**STAFF REPORT**  
**CITY OF BEVERLY HILLS**

**For the Design Review Commission  
Meeting of June 3, 2010**

**SUBJECT:** A request for an R-1 Design Review Permit to allow a new two-story single-family residence located in the Central Area of the City, south of Santa Monica Boulevard at **163 North Hamel Drive.** (PL 101 1787)

Proposed

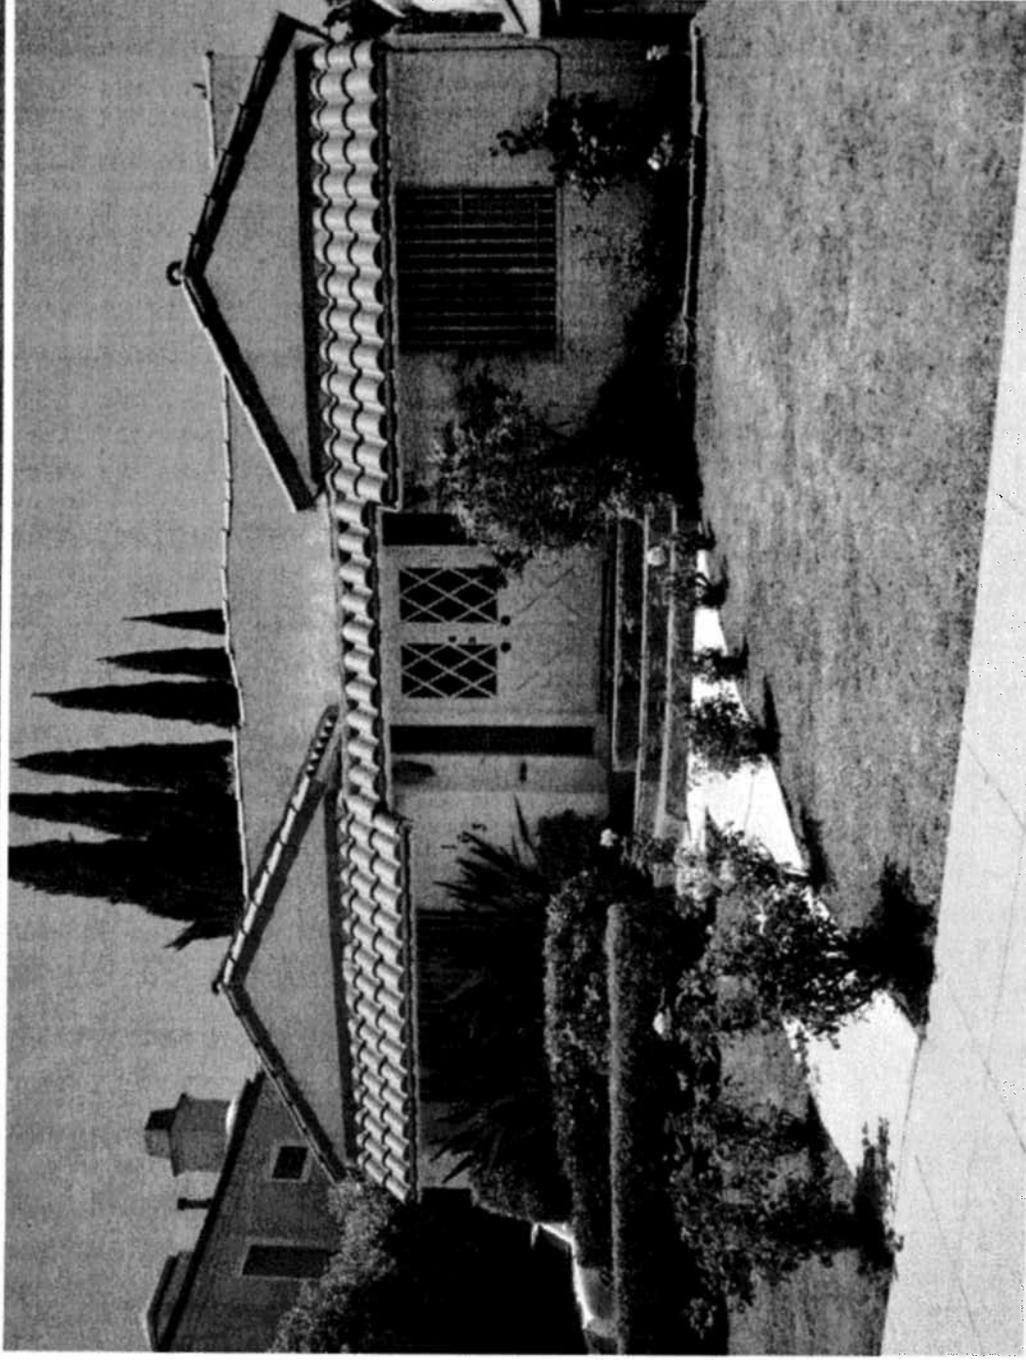
It should be noted that the landscape plan does not include the required two-three foot paving hedge required by Code Section 10-3-2422(F). A condition of approval to comply with this code section has been added. In addition, the landscape plan does not propose any landscaping along the side elevations of the residence (landscape plan shows concrete paving). Staff is recommending that the Applicant propose some landscaping in these areas.

Staff has concerns with the scale and proportions of the façade design. The Commission may wish to discuss how these features can be refined.

1. A paving landscape buffer shall be added to the landscaping plan in accordance with BHMC Code Section 10-3-2422(F).
